**FEMA Levee Certification
Ventura County, California**

**Arroyo Simi Levee (AS-6)
First Street to Erringer Road**

**Evaluation Report
February 13, 2009**

- Exhibit 1 – Field Investigation Report
- Exhibit 2 – Preliminary Evaluation of Levee System Profiles
- Exhibit 3 – As-Built Plans Status List
- Exhibit 4 – Responses to Comments on Draft Evaluation Report

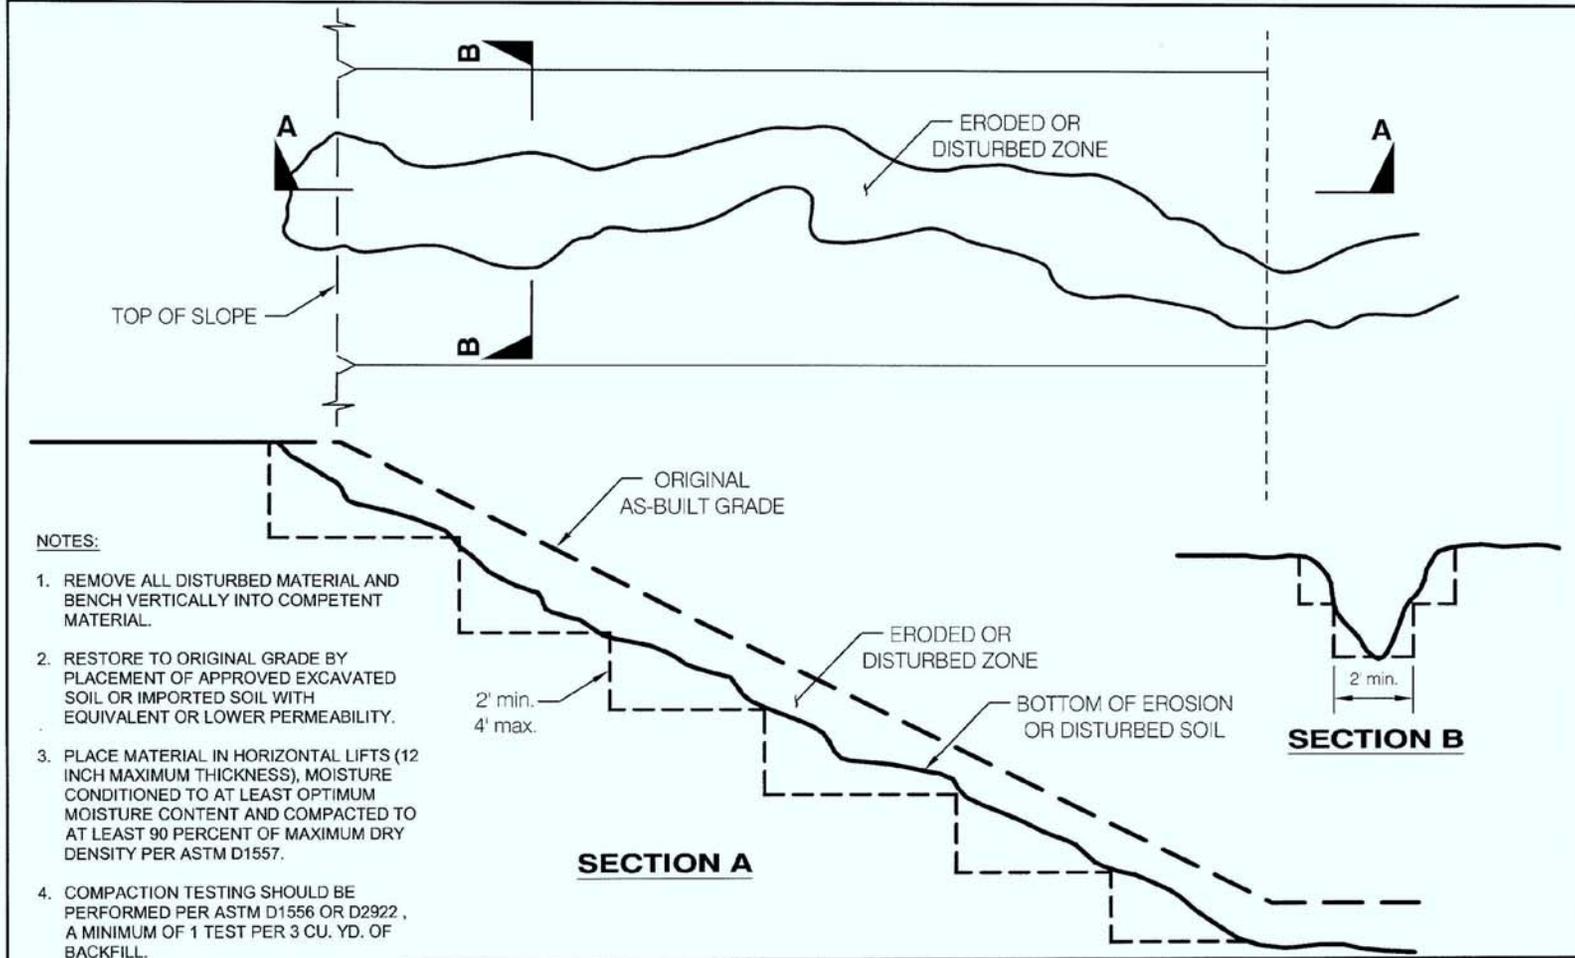
<p>4. Can Tetra Tech provide specs for compaction and grading requirements? Discuss major and minor repair examples.</p>	<p>Compaction requirements are detailed on the attached Figures 1 and 2. Major repair examples include any erosion feature that is deeper than 1 foot or that is greater than 2 feet wide. Major and minor animal burrows are discussed in item 1.</p>
<p>5. Can in-kind materials be used for backfill?</p>	<p>In-kind backfill would be materials free of organic or deleterious debris that has similar or lower permeability than the levee material. These materials could consist of excavated soil, imported soil, concrete, or slurry, and shall be evaluated by the testing and materials lab.</p>
<p>6. Discuss documentation/inspection requirements for verification of grading.</p>	<p>The requirements for verification of grading are discussed above.</p>

1. REMOVE ALL DISTURBED MATERIAL AND BENCH VERTICALLY INTO COMPETENT MATERIAL.
2. RESTORE TO ORIGINAL GRADE BY PLACEMENT OF APPROVED EXCAVATED SOIL OR IMPORTED SOIL WITH EQUIVALENT OR LOWER PERMEABILITY.
3. PLACE MATERIAL IN HORIZONTAL LIFTS (12 INCH MAXIMUM THICKNESS), MOISTURE CONDITIONED TO AT LEAST OPTIMUM MOISTURE CONTENT AND COMPACTED TO AT LEAST 90 PERCENT OF MAXIMUM DRY DENSITY PER ASTM D1557.
4. COMPACTION TESTING SHOULD BE PERFORMED PER ASTM D1556 OR D2922 , A MINIMUM OF 1 TEST PER 3 CU. YD. OF BACKFILL.

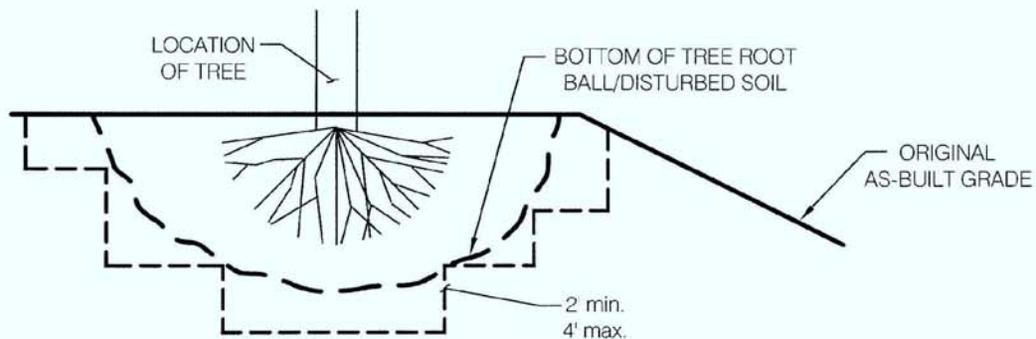
<p>2. Please describe methods for vegetation and rootball removal.</p>	<p>4" DIAMETER TRUNK OR GREATER: Cut the woody vegetation approximately two (2) feet above ground level leaving a prominent stump for use in the rootball extraction process. Remove the stump and rootball by pulling or extracting with a backhoe or similar equipment. Clean the rootball cavity of all loose soil and remaining root system (roots greater than 1/2" diameter). Prepare the cavity by excavating per FIGURE 2. Backfill with excavated soil or imported soil with equivalent or lower permeability. Place material in horizontal lifts no greater than twelve (12) inches. Moisture conditioned to at least optimum moisture content and compacted to at least ninety (90) percent of the maximum dry density of the fill soil per ASTM D1557. Compaction typically requires the use of manually operated compaction equipment or compaction attachment to a backhoe. Compaction testing should be performed per ASTM D1556 or D2922. A minimum of one (1) test per three (3) cubic yards of backfill.</p> <p>2"-4" DIAMETER TRUNK: Cut the woody vegetation stump flush with the ground. Treat the stump with a protective coating similar to polyurethane to prolong the decay process.</p>

1. REMOVE ALL DISTURBED MATERIAL AND BENCH VERTICALLY INTO COMPETENT MATERIAL.
2. RESTORE TO ORIGINAL GRADE BY PLACEMENT OF APPROVED EXCAVATED SOIL OR IMPORTED SOIL WITH EQUIVALENT OR LOWER PERMEABILITY.
3. PLACE MATERIAL IN HORIZONTAL LIFTS (12 INCH MAXIMUM THICKNESS), MOISTURE CONDITIONED TO AT LEAST OPTIMUM MOISTURE CONTENT AND COMPACTED TO AT LEAST 90 PERCENT OF MAXIMUM DRY DENSITY PER ASTM D1557.
4. COMPACTION TESTING SHOULD BE PERFORMED PER ASTM D1556 OR D2922, A MINIMUM OF 1 TEST PER 3 CU. YD. OF BACKFILL.
